# CITY OF ALBUQUERQUE

RE: **Volcano Cliffs Unit 2 SAD 227**  
**8024 Kibo Dr. NW**  
**Grading and Drainage Plan**  
**Engineers Stamp Date; 10/11/2022 (E10D122)**  
**Pad Certification Date; 1/10/2023**

## DRAINAGE AND TRANSPORTATION INFORMATION SHEET (REV 6/2018)

10/11/22 DAVID SOULE P.E. #14522	8024 KIBO	DRAWN BY WCVJ
	GRADING AND DRAINAGE PLAN	DATE 10-10-22
 Rio Grande Engineering 1606 CENTRAL AVENUE SE SUITE 201 ALBUQUERQUE, NM 87106 (505) 972-9398		20220070-LAYOUT-10-10-22
		SHEET #
		JOB # 20220022

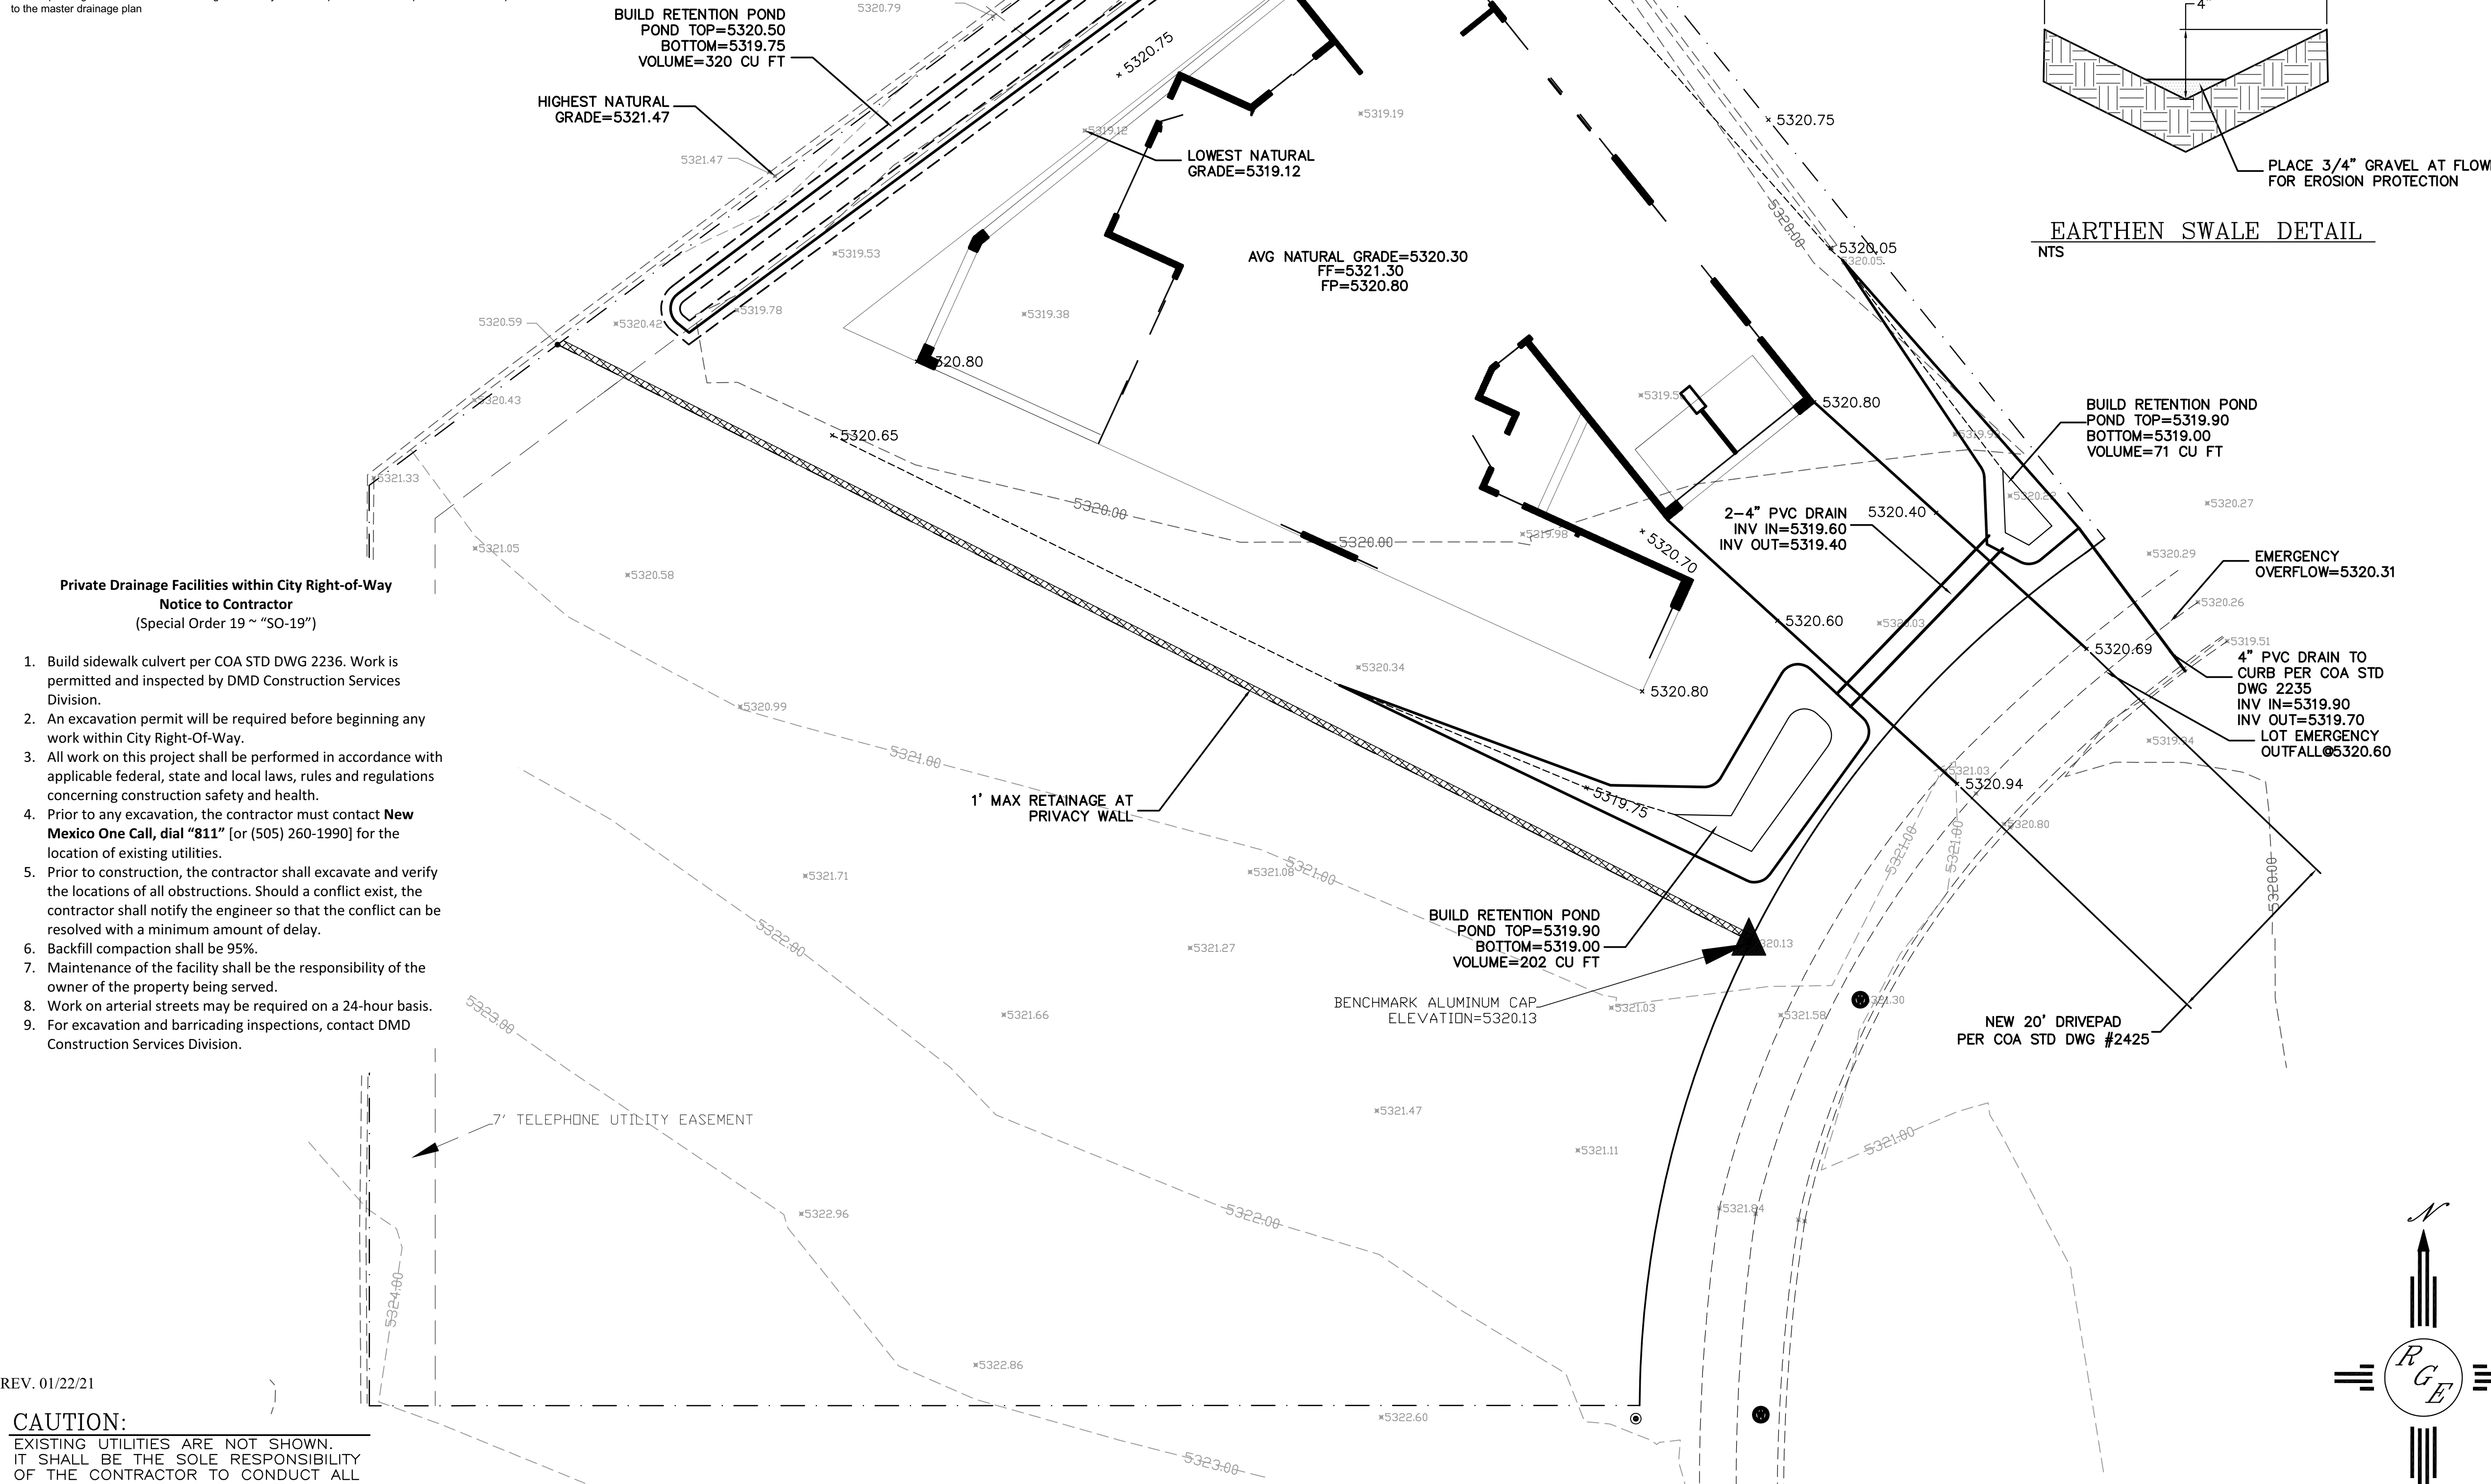
Based upon the information provided in your submittal received 1/11/2023, this plan is approved for Building permit.

**Reiterate to the Owner/Contractor that a separate permit for a garden/retaining wall must be obtained, with the approved G&D plan and Pad Certification. Inform the owner & Contractor that dirt is not allowed in the public right of way to climb the curb. Crusher fines or lumber are allowed. If dirt is used this will delay the permitting process.**

Prior to Certificate of Occupancy release, Engineer Certification per the DPM checklist of this plan will be required.
